CONSTITUTION STORAGE DEVELOPMENT

PCD Filing No.: PPR-2224

Traffic Impact Study (Memorandum) and Deviation Request Table of Contents

**DEVIATION REQUEST
 AND DECISION FORM**

Attachment I
Site Plan
Synchro Reports

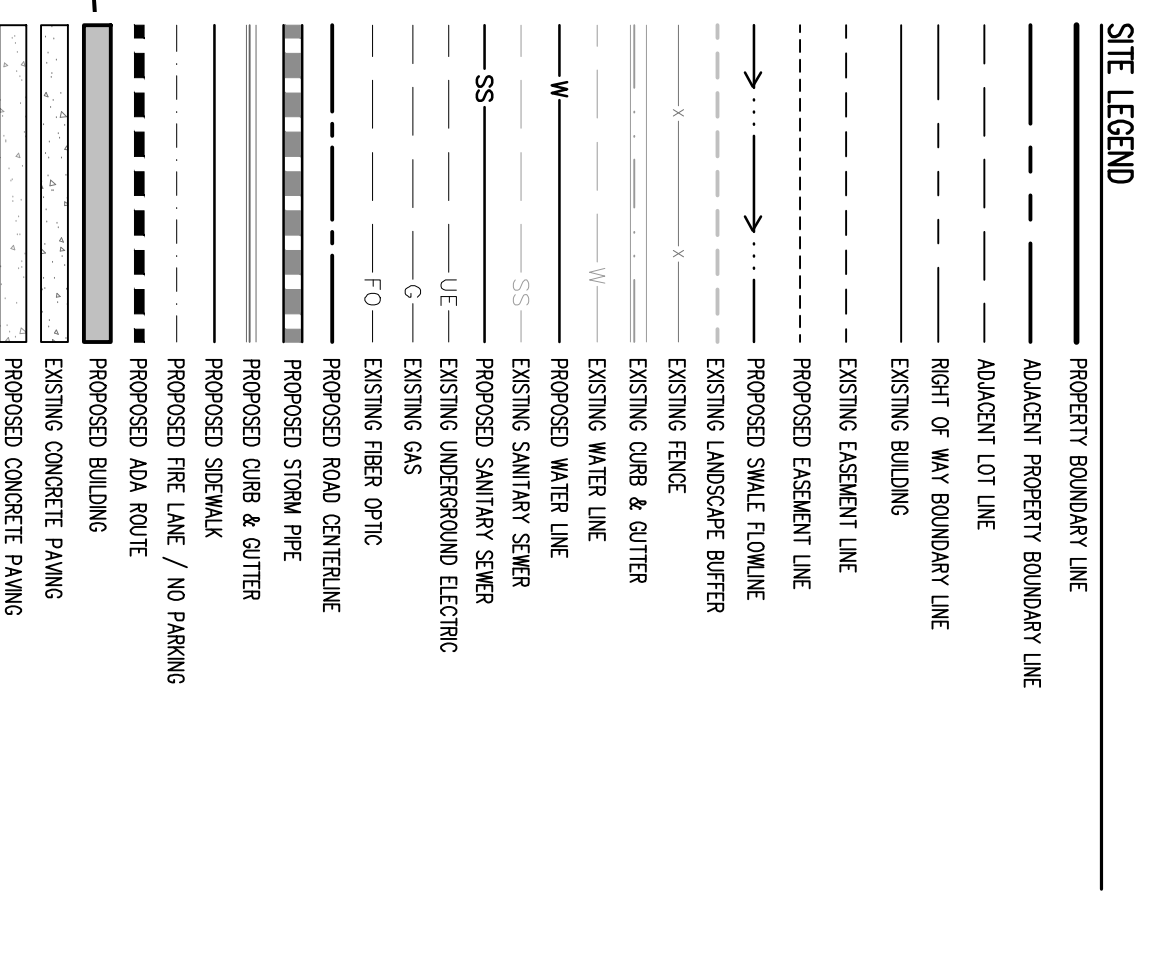
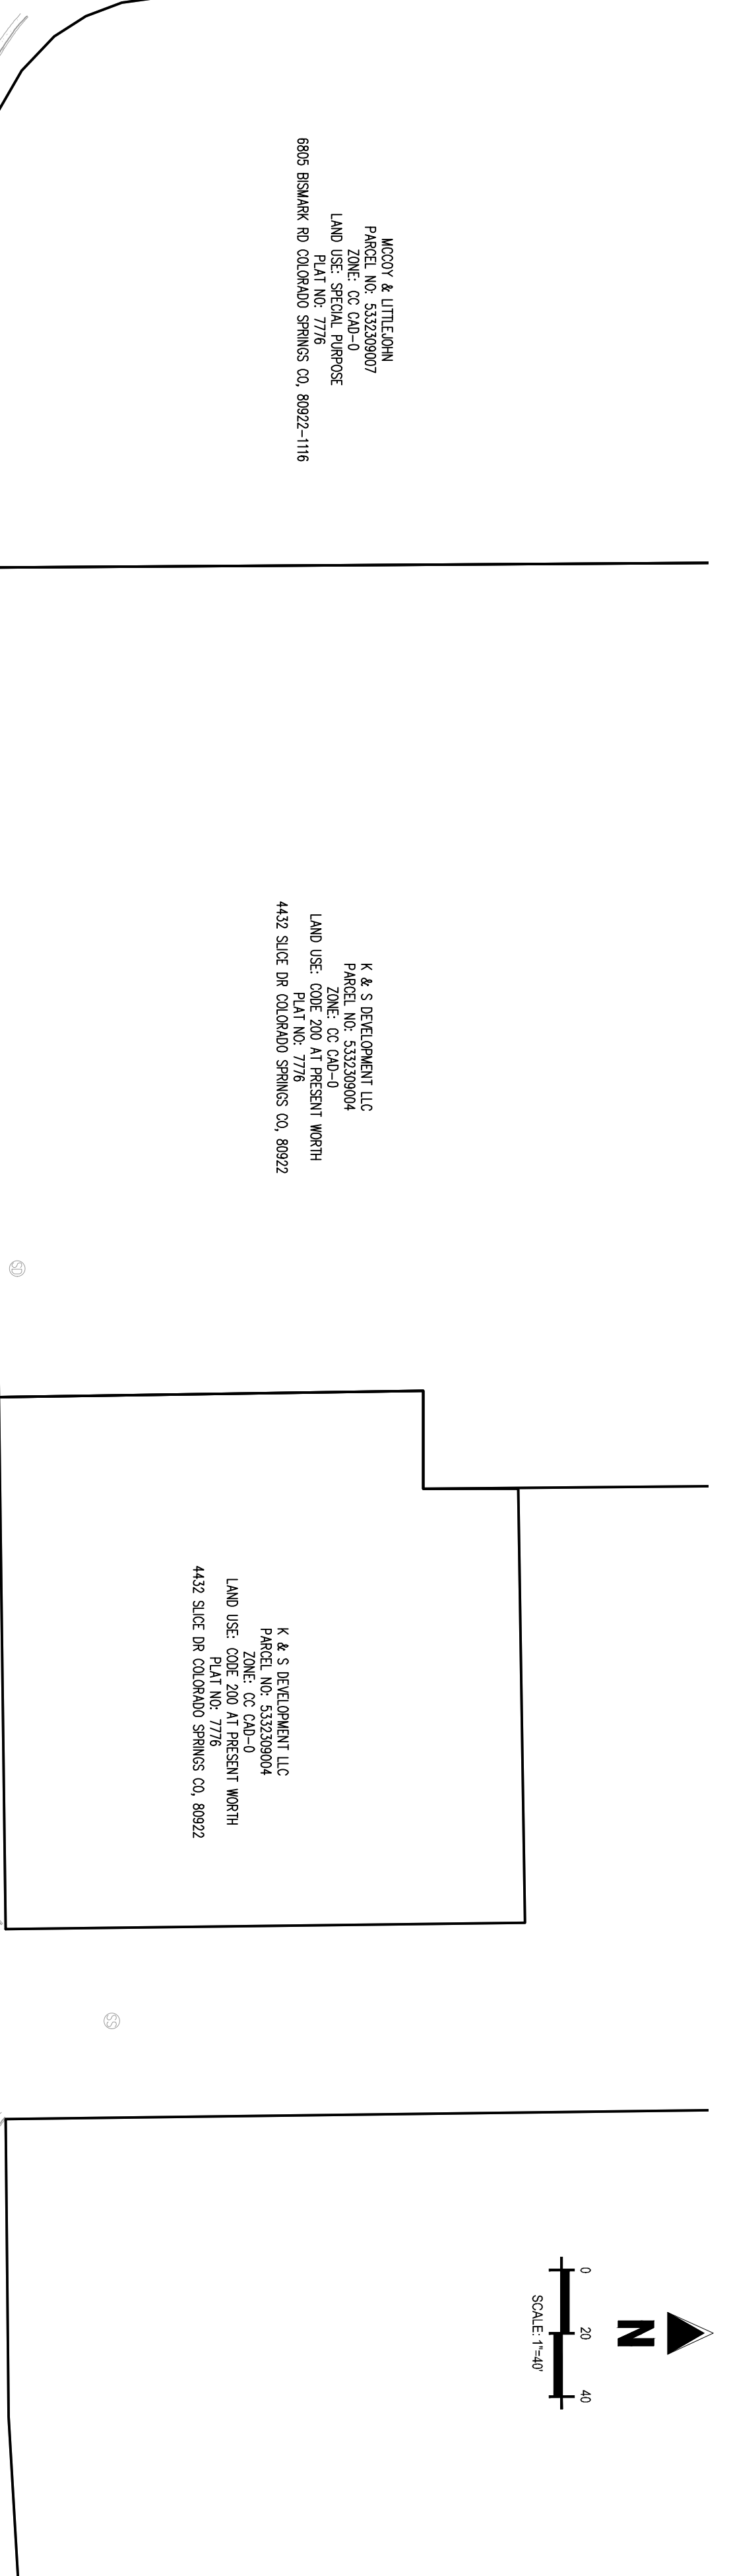
-In the Traffic Memo discuss queuing on the Peterson Rd access point. Also discuss whether an auxiliary lane would it increase safety for that access point and if it would fit in the ROW. Explanation for why auxiliary lanes does not imply that the access point is safe. Actual traffic amounts for turn lanes will need to be provided to address comment.

Vehicle Tracking Plan

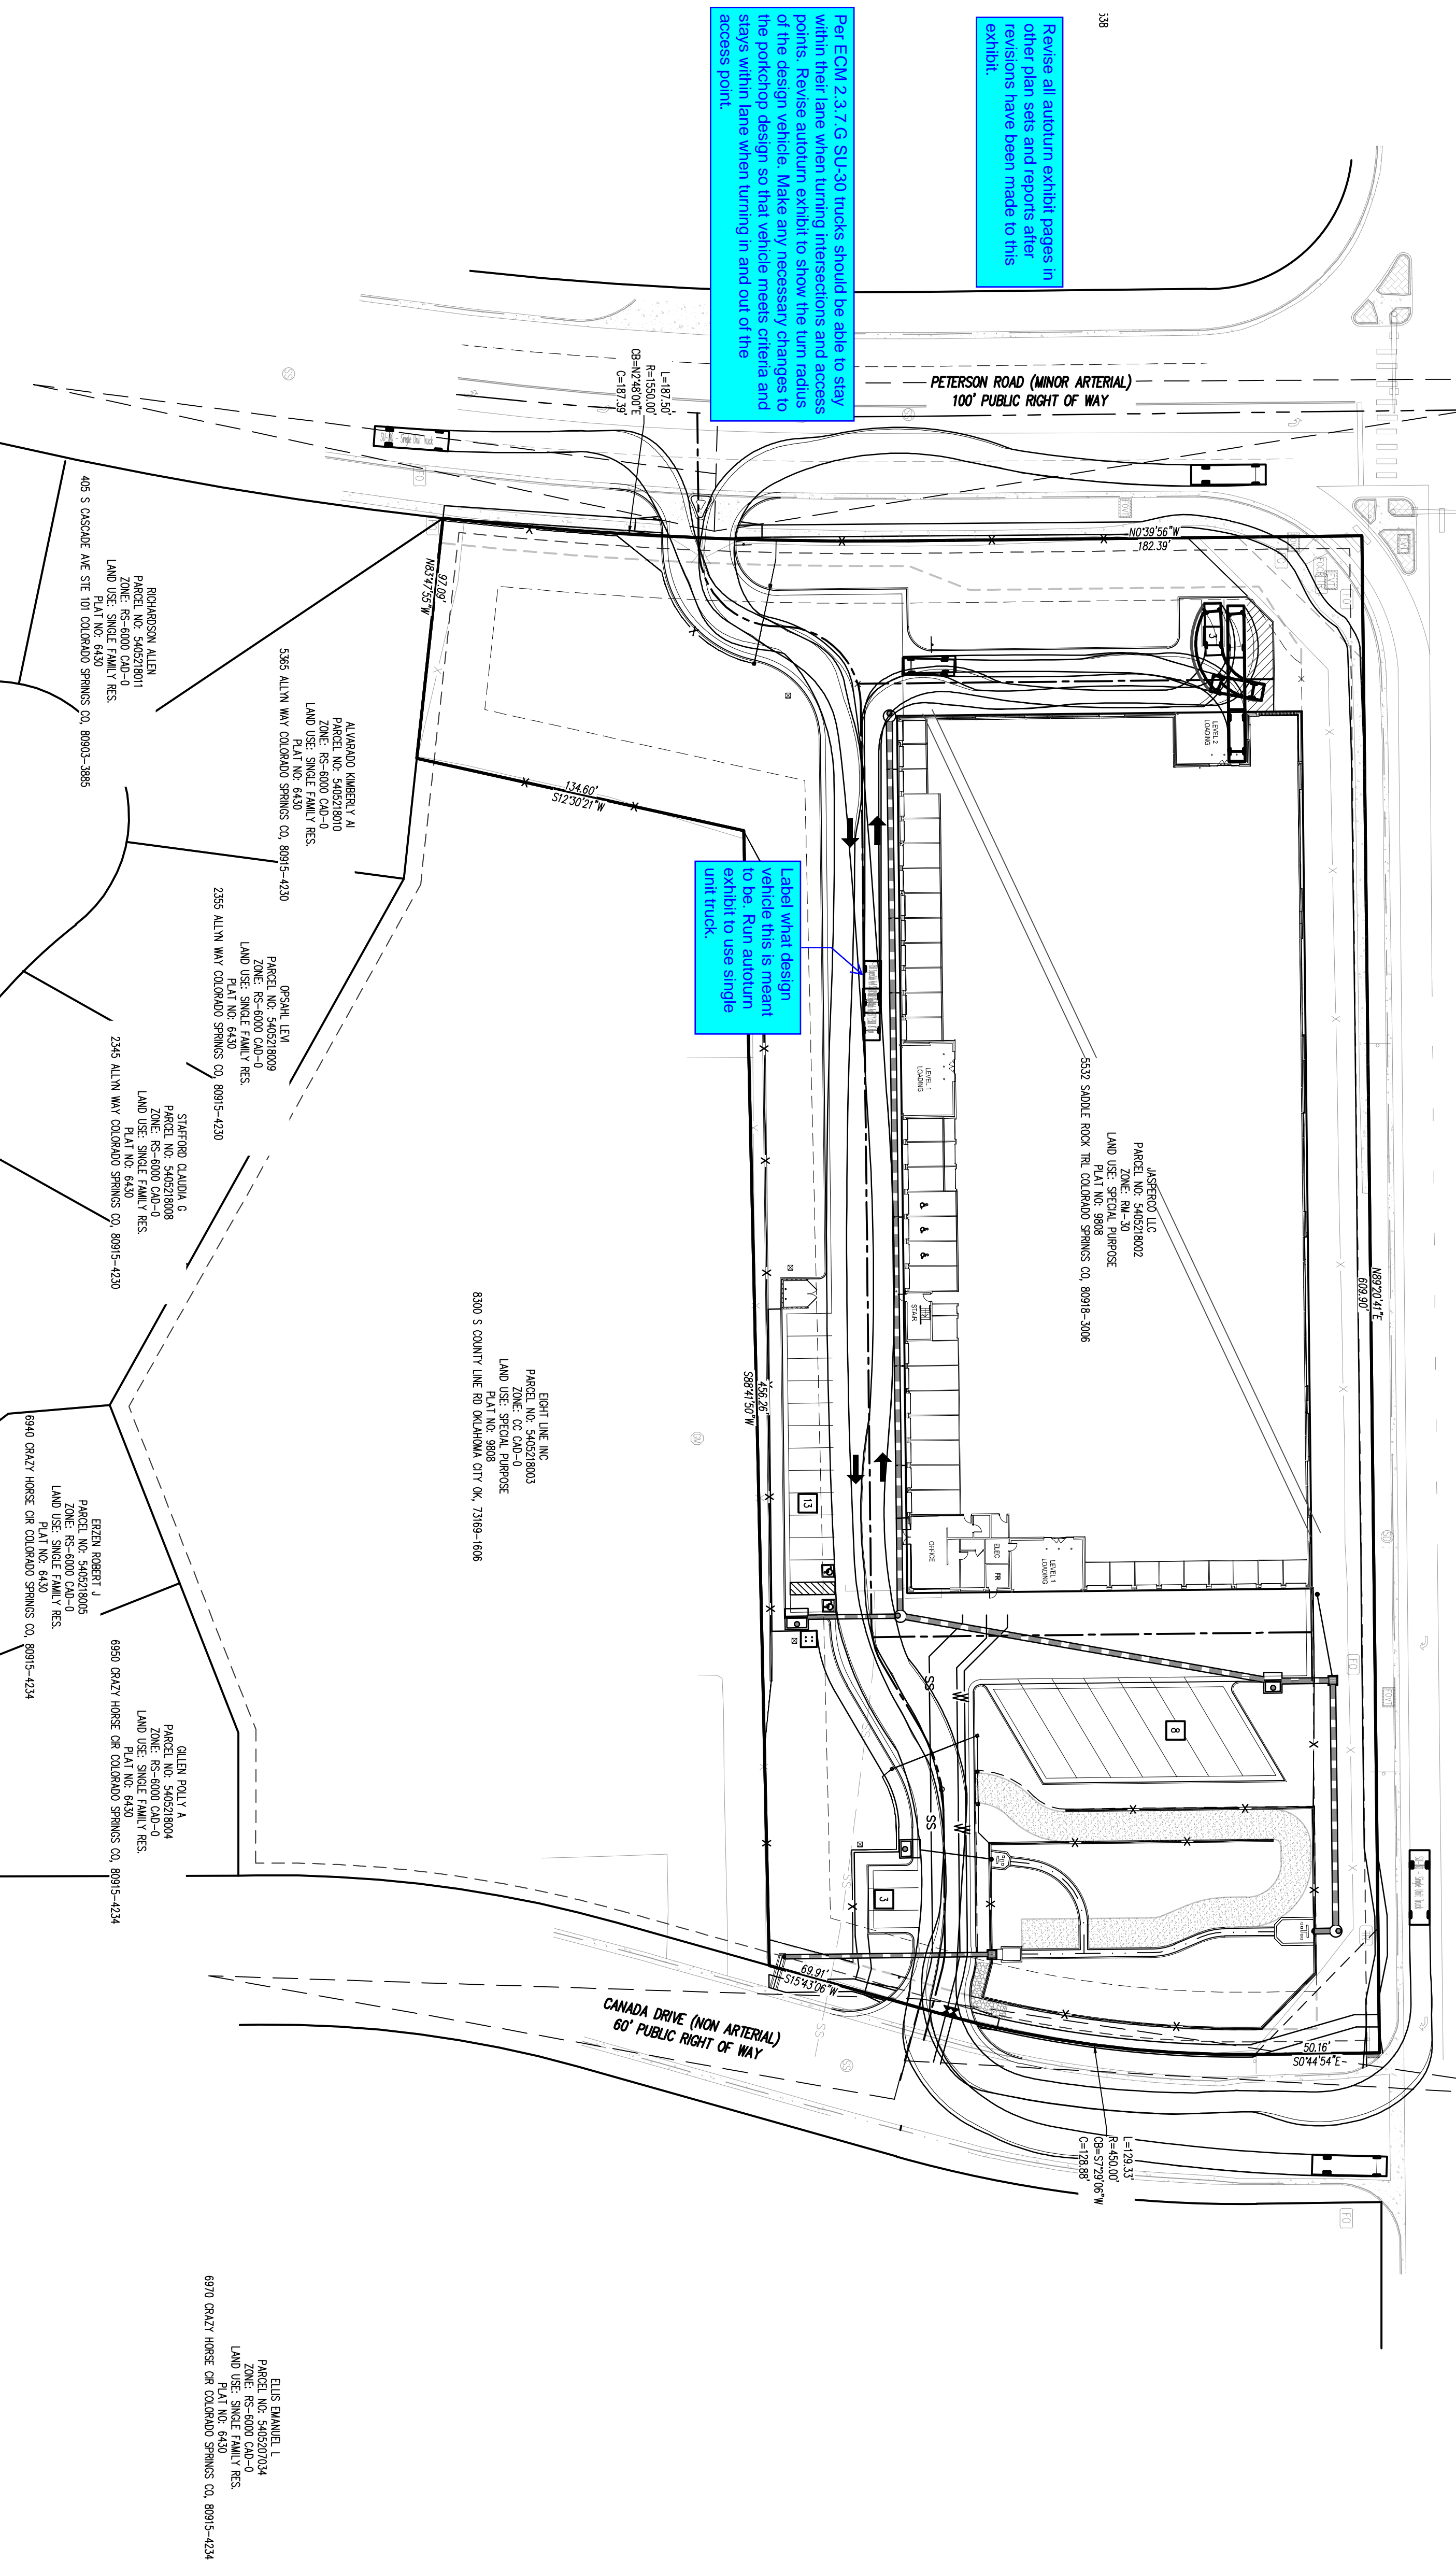
Revise all autium exhibit pages in other plan sets and reports after revisions have been made to this exhibit.

Label what design vehicle this is meant to be. Run autium exhibit to use single unit truck.

Per FGM 2.7.G.SU-30 trucks should be able to stay within their lanes when turning intersections and access points. Revise autium exhibit to show the turn radius of the design vehicles. Make any necessary changes to the parking design so that vehicle meets criteria and stays within lane when turning in and out of the access point.
